**NOTICE OF A REGULAR MEETING
OF THE DESIGN REVIEW BOARD OF THE TOWN OF CLARKDALE**

DISCUSSION & POSSIBLE ACTION: DRB-091002 – A request to update the architecture for windows, doors, canopies and add packaged terminal air conditioners to the building on 921 Main Street – Parcel #400-03-158.

Agenda Item: Discussion/possible action DRB-091002 – A request to update the architecture for windows, doors, canopies and add packaged terminal air conditioners to the building on 921 Main Street.

THE CLARKDALE HOTEL AT TOWN PARK

HOTEL SIGNAGE

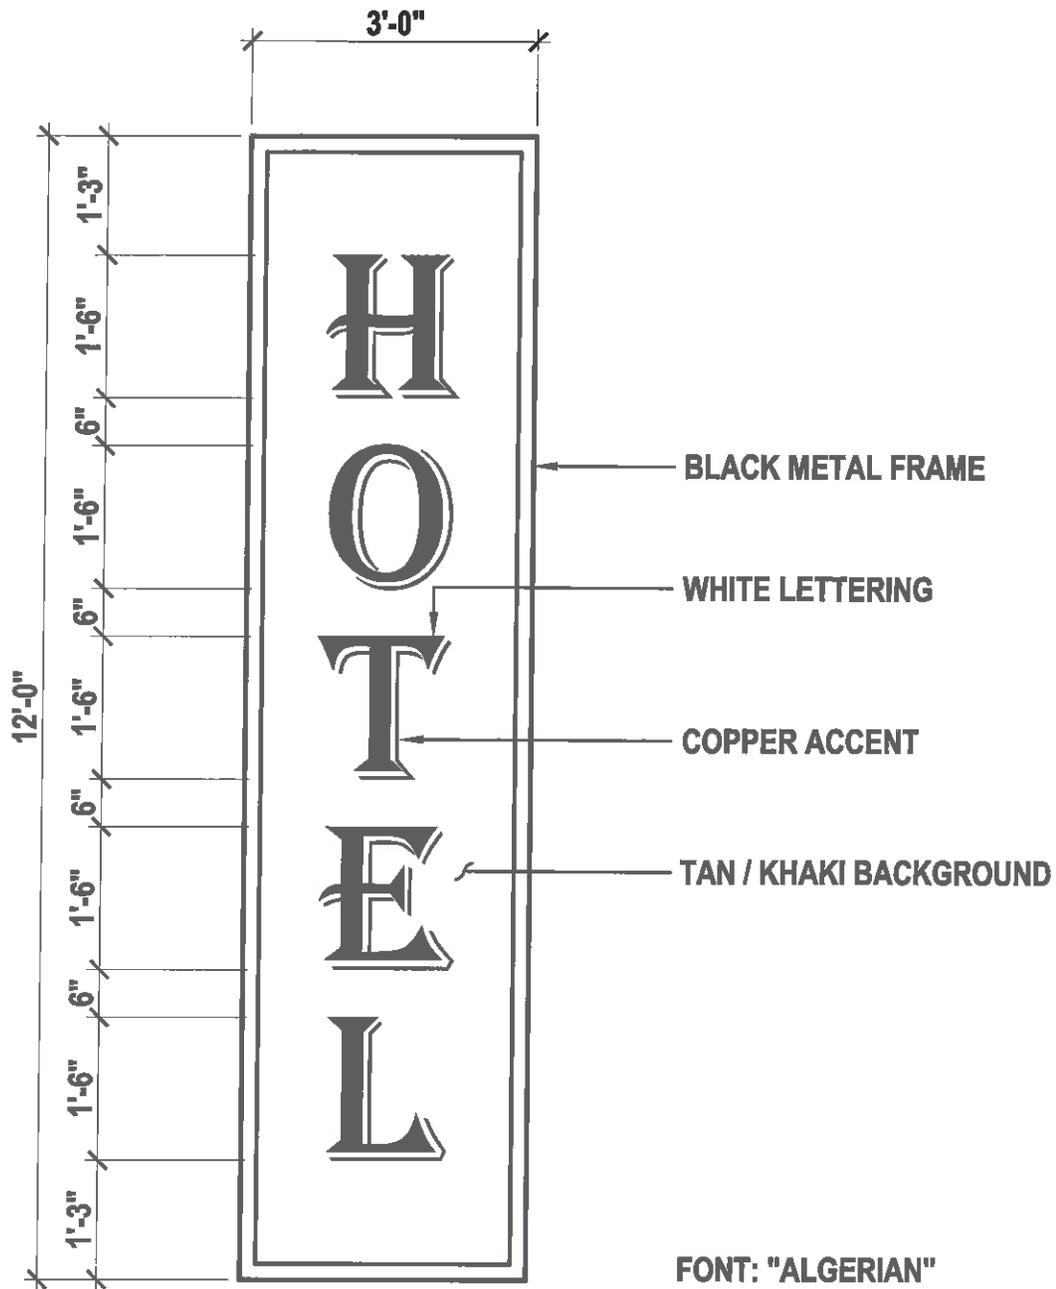
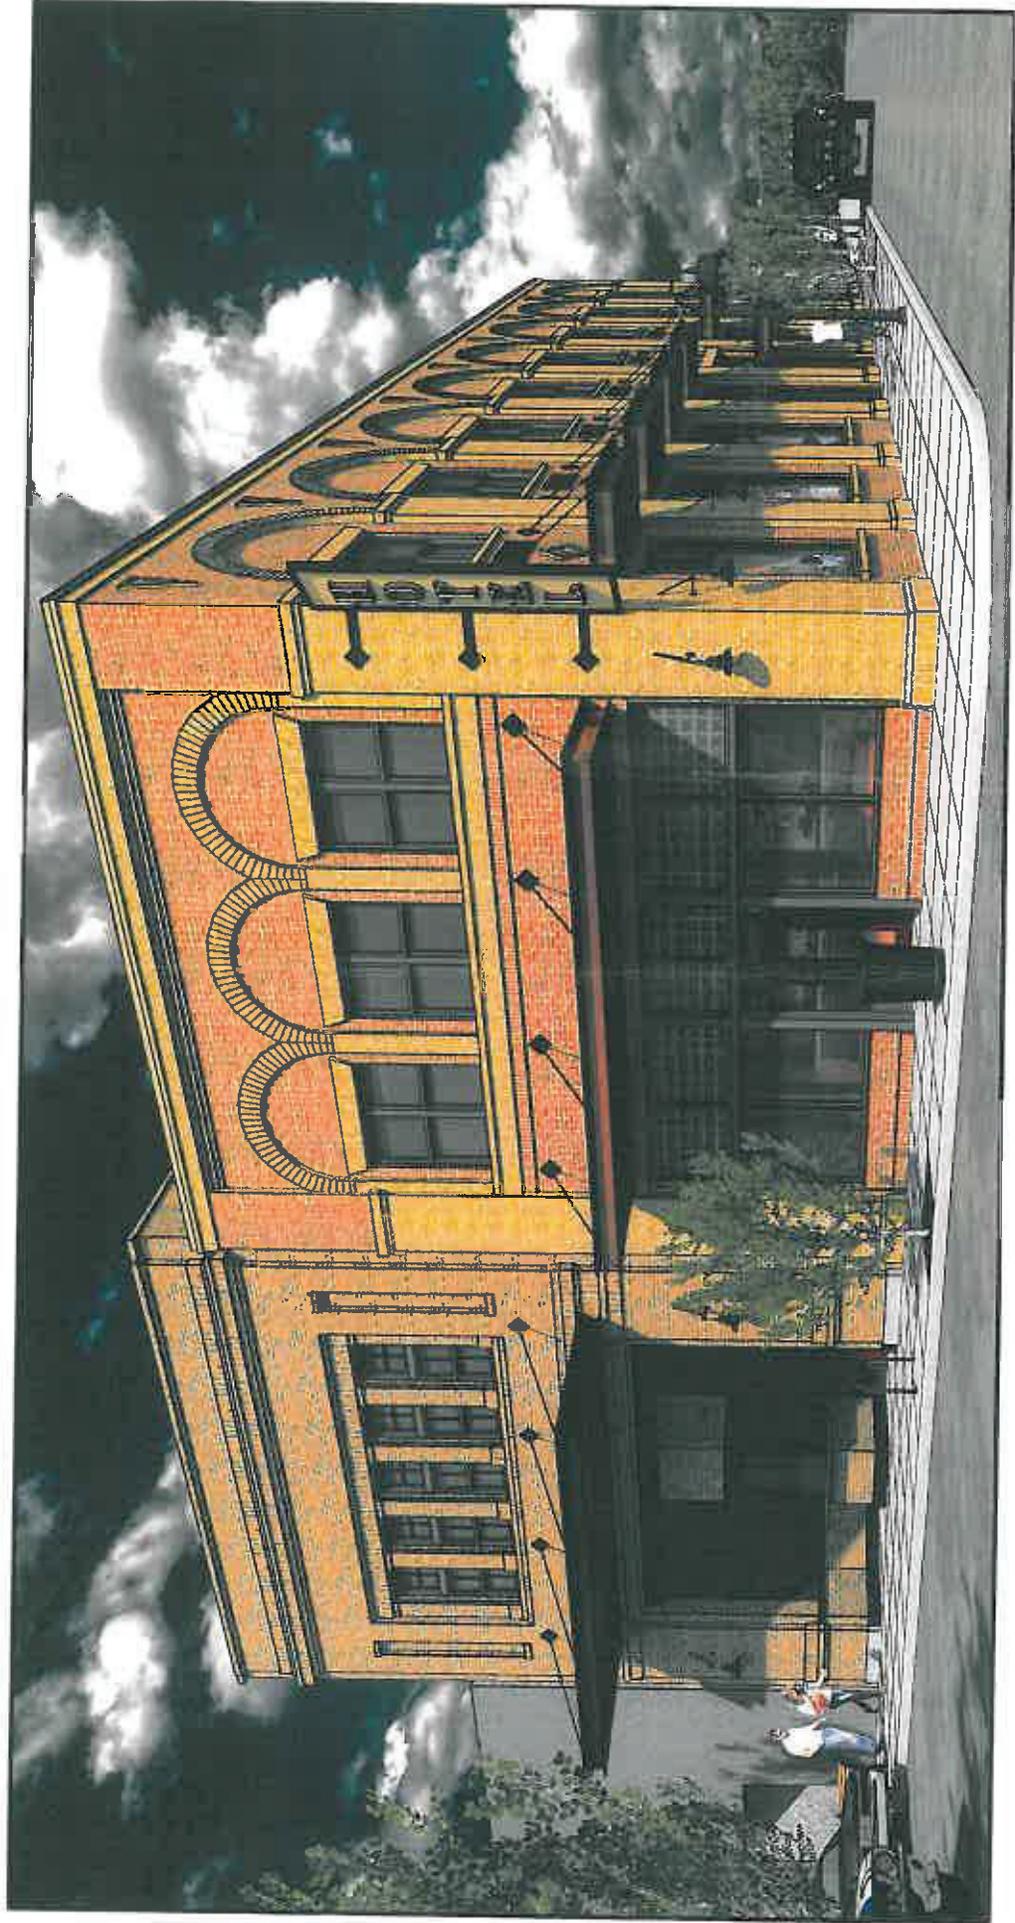
1. ***No more than three different fonts should be used in the text for the sign.*** The proposed sign has (1) font and does not exceed the suggested font counts.

2. ***Sign should have no more than 50 percent opacity. Dark background colors are preferred.*** The proposed sign complies with the new criteria, featuring bronze lettering with deep crimson highlights on a travertine background.
3. ***Signs should be non-reflective.*** The proposed sign has no reflectivity.
4. ***Signs should be readable from the closest major road.*** The readability of the sign complies with the new criteria.

Zoning Code Chapter 7, Section 7-8 I. Permitted Signs. Projecting Signs: The hotel projecting sign complies with this code.

1. ***Maximum height equals top of wall.*** The hotel sign is approximately 9 ft. high above grade and approximately 8 feet below the top of the wall
2. ***No signage shall extend over public property except in the Central Business district and in no case shall the bottom of the sign be nearer than 9 vertical feet to grade, nor shall the leading edge of the sign be nearer than 2 linear feet to the curb.*** Application complies.

3. ***Maximum number equals one per business.*** The hotel projecting sign complies with projecting sign counts.
4. ***An agreement indemnifying the Town of Clarkdale from any liability is required if the sign projects over public right-of-way.*** Proposed sign projects over the public right-of-way. Staff has included a stipulation (#2) requiring this agreement.

5. ***See Section 7-9 of this Code for maximum sign square footage.*** The maximum sign square footage for this parcel is estimated to be 276 square feet based on a measured 184 linear street frontage. After the subtraction of 20 square feet allocated to the Verde Adventures signage the remaining square footage available will be 256 square feet. The 36 square feet of proposed signage will leave 220 square feet of available for signage along Tenth Street.

1. All additional signage shall be installed as reviewed and approved by the Design Review Board.
2. An agreement indemnifying the Town of Clarkdale from any liability is required because the sign projects over public right-of-way.
3. All exterior lighting shall be fully shielded and meet all requirements of Chapter Eight of the Town of Clarkdale Zoning Code.
4. A right-of-way permit from the Public Works Department will be required for the projecting sign and canopies.
5. All construction shall be inspected by the Town of Clarkdale Building Official.
6. The address of 921 Main Street will be visible and in compliance with the Clarkdale Fire District code requirements.
